Access Compliance Report

Public Rights-of-Way

(Curb Ramps)

Intersection ID: 20282	Main Street: COLWYN_PL	Cross Street: ARBOR_WAY	Location: SE
ADA ID: C2256AB50B26	Ramp Type: Directional1	Initial Pass/Fail: Fail	Overall Compliance: No
Severity Score: 21.25			
Codes/Mitigation Info/Possible Solution		Field Measurements/Component Compliance

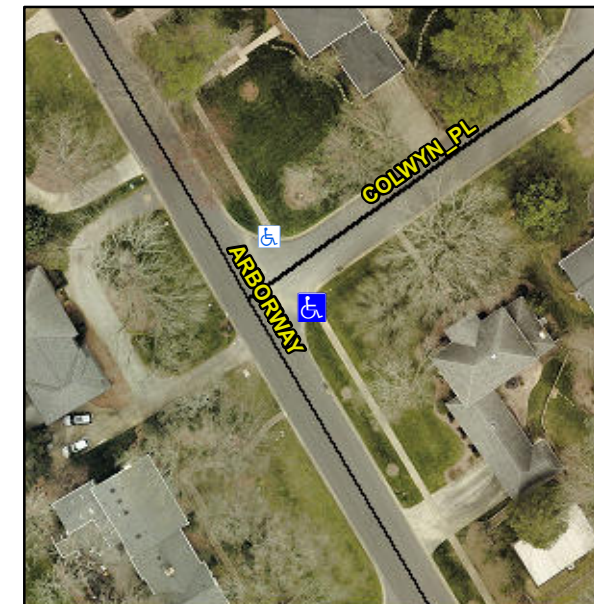
R304.5.1, R304.5.3

Compliance	Description	Data	Compliance	Description	Data
N/A	Ramp Length (in)	55.0	N/A	Grade Break?	N/A
No	Ramp Width (in)	44.5	N/A	Grade Break Slope (%)	0.0
Yes	Ramp Slope (%)	2.3	N/A	Grade Break XSlope (%)	0.0
No	Ramp XSlope (%)	5.4			
N/A	Flare Type LT	N/A	N/A	Flare Type RT	N/A
N/A	Flare Slope LT (%)	N/A	N/A	Flare Slope RT (%)	0.0
N/A	Flare Traversable LT?	N/A	N/A	Flare Traversable RT?	N/A
N/A	Landing Length (in)	0.0	N/A	DWS Provided?	N/A
N/A	Landing Width (in)	0.0	N/A	DWS Contrast?	N/A
N/A	Landing Slope (%)	0.0	N/A	DWS Length (in)	N/A
N/A	Landing X Slope (%)	0.0	N/A	DWS Full Width?	N/A
N/A	Landing Curb? (Y/N)	N/A	N/A	DWS Offset LT (in)	N/A
N/A	Shared Landing?	N/A	N/A	DWS Offset RT (in)	N/A
N/A	Gutter Ponding?	0.0	N/A	Gutter Slope (%)	N/A
N/A	Gutter Lip Ht (in)	0.0	N/A	Gutter X Slope (%)	N/A
N/A	Painted X Walk1?	No		Road Slope (%)	1.1
	X Walk 1 Direction	To NW		Road X Slope (%)	1.2
	X Walk 1 Width (in)	N/A		Clear Space?	N/A

Remove & Replace Entire Ramp.
